Well Name: PRESTON FEDERAL

Well Number: 14

Type of Submission: Notice of Intent

Type of Action: Plug and Abandonment

Wellbore schematics attached

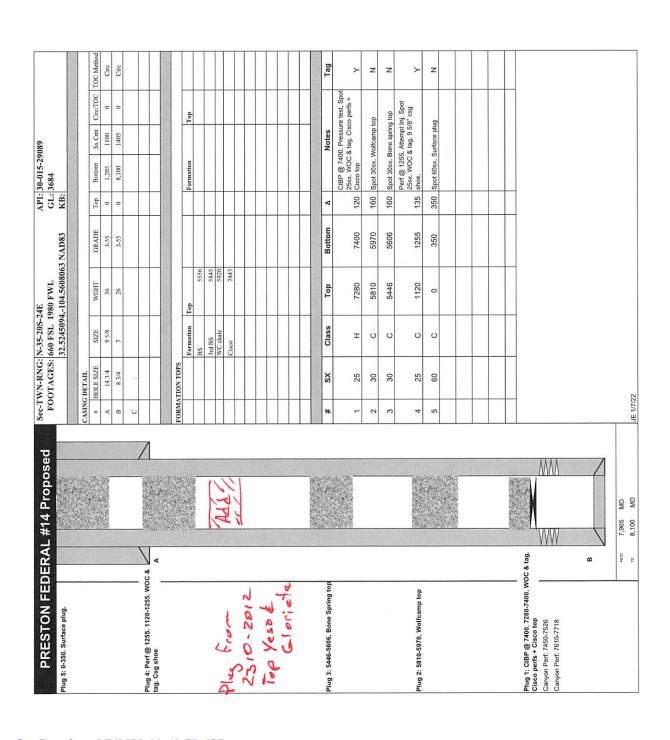
* Add Plug(s) Spot plug from 2310'-2012' (covers
Top of Yeso and Glorieta).
